SDG&E 02/15/13 Complete Response
Cleveland National Forest Review of the San Diego Gas & Electric Preliminary Plan of
Development for the Master Special Use Permit (Dated December 7, 2012)

SECTION I. POD REVIEW

Figure 1: TL626 Potential Alternative Study Corridor USFS MSUP/CNF Power Line Replacement Projects

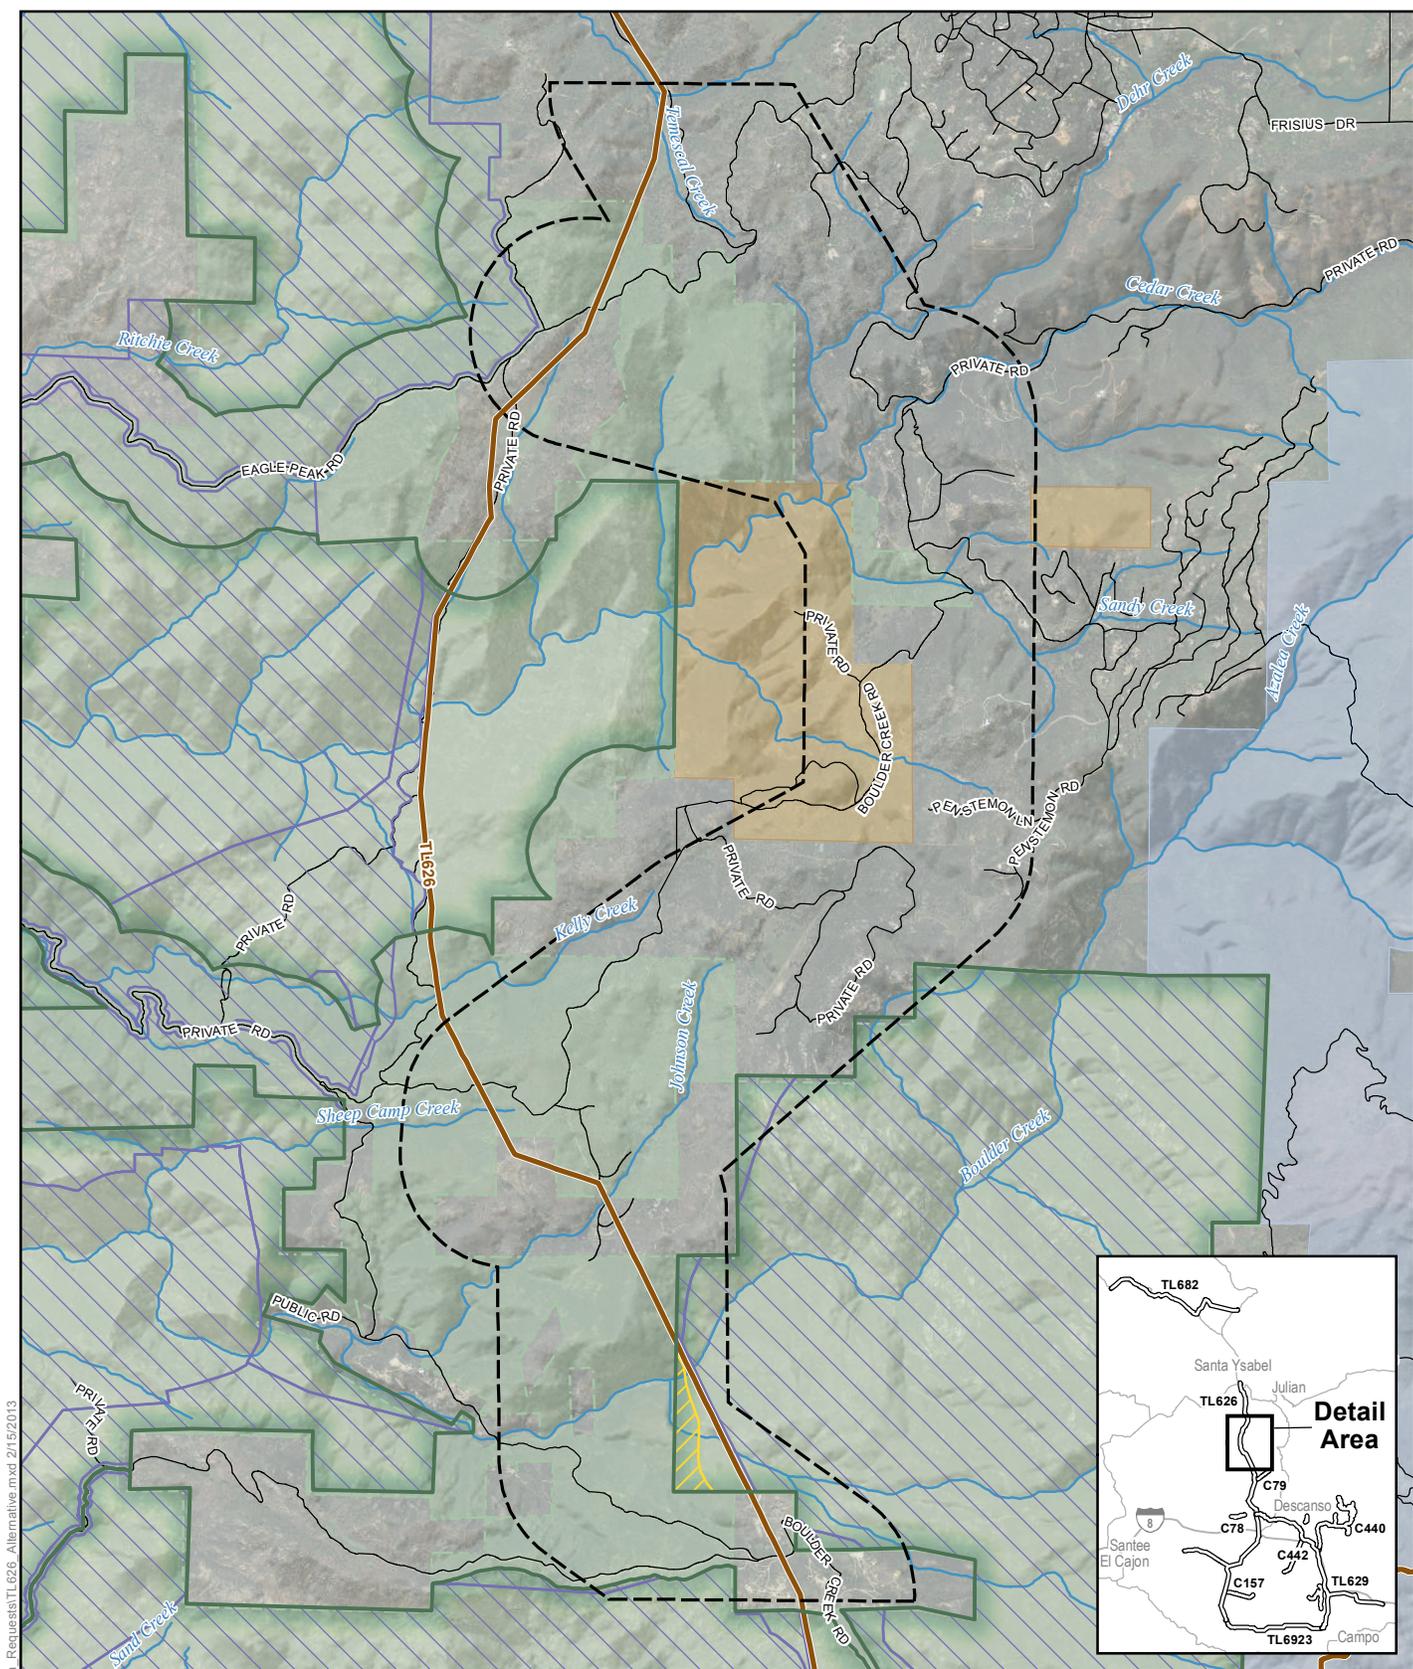
This TL crosses through an area with high resource concerns, and the current condition does not meet the LMP desired resource condition for the area. It is also being considered for a Recommended Wilderness Land Use Zone as part of the LMP amendment project. The Forest Service wants to fully develop the relocation alternative and consider it in detail in the EIS. The Forest Service will work with SDG&E to identify the best alternative location for consideration.

SDG&E will work with the USFS to identify feasible alternatives necessary to avoid impacts to resources. SDG&E notes that TL626 (including access roads) is outside of the areas identified by the USFS as proposed Recommended Wilderness, and that the area has not yet been formally recommended as Wilderness. SDG&E will continue to participate in the USFS' LMP amendment process to request that the Recommended Wilderness Land Use Zone exclude SDG&E facilities. SDG&E would not anticipate that an alternative that avoids Recommended Wilderness is required unless the adopted Recommended Wilderness area includes SDG&E facilities.

Nonetheless, at the USFS's request, SDG&E is working to identify a possible alternative location for the segment of this power line between poles Z372142 and Z213670, which is the segment of TL626 that crosses the Inventoried Roadless Area in the vicinity of the proposed Recommended Wilderness Land Use Zone. Using available existing topographical, road, parcel, land use, and environmental resource data, SDG&E has created an approximately 3,000-foot-wide preliminary study corridor within which a potential alternative route may be identified; this study corridor is shown in Figure 1: TL626 Potential Alternative Study Corridor. The study corridor's location takes into consideration the avoidance of the USFS's proposed Recommended Wilderness Land Use Zones and Inventoried Roadless Areas, while at the same time ensuring connectivity between Descanso and Santa Ysabel substations and continued service to customers served by distribution underbuild along this segment of the power line. As a result, the study corridor includes an area somewhat longer than requested by the USFS, extending from pole Z372113 to Z213678.

Figure 2: Proposed Turn-Around Locations for TL626 USFS MSUP/CNF Power Line Replacement Projects

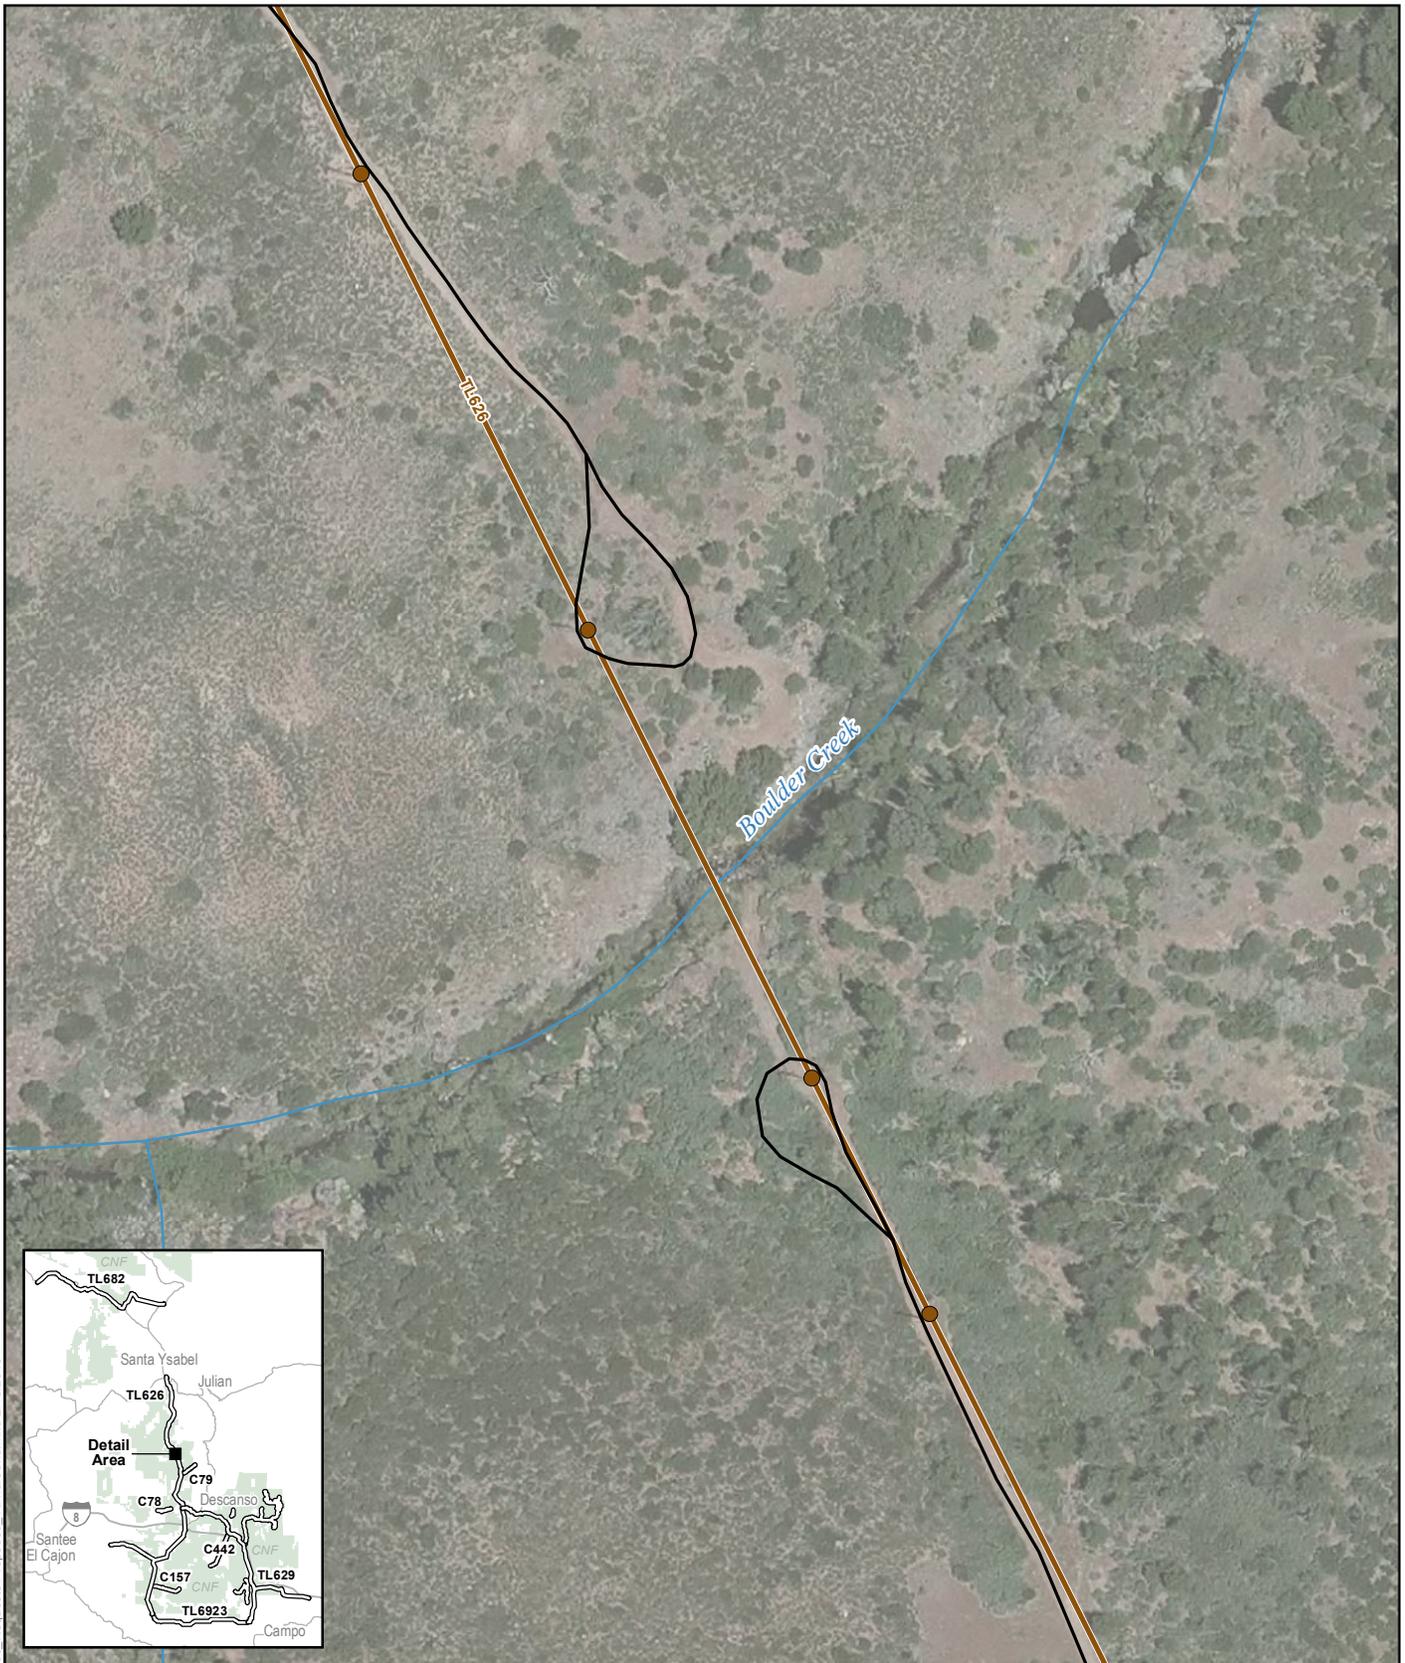
The Forest Service and SDG&E have been working successfully over the last few years to address erosion concerns with specific road segments (for example, the roads on the north-slope of Barber Mt. and along Boulder Creek). The proposed action should reflect these actions and provide greater detail as to how these concerns will be addressed in the MSUP.

The Proposed Action also includes actions that have been successful along Boulder Creek, including prohibiting vehicle use within Boulder Creek. The Proposed Action further includes permanent reconfiguration of the existing access road to prohibit travel through Boulder Creek for access to poles Z372130 and Z372131. The Proposed Action instead includes turn-around locations on either side of Boulder Creek, which would eliminate the creek crossing while maintaining necessary access to these poles. The change has been included in the Proposed Action, as shown in Figure 2: Proposed Turn-Around Locations for TL626.

Section 4.5 Access Road Modification of the Preliminary POD will be revised to provide additional detail regarding these actions, as well as reflect SDG&E's survey and notification procedures regarding access roads and address erosion concerns prior to construction.
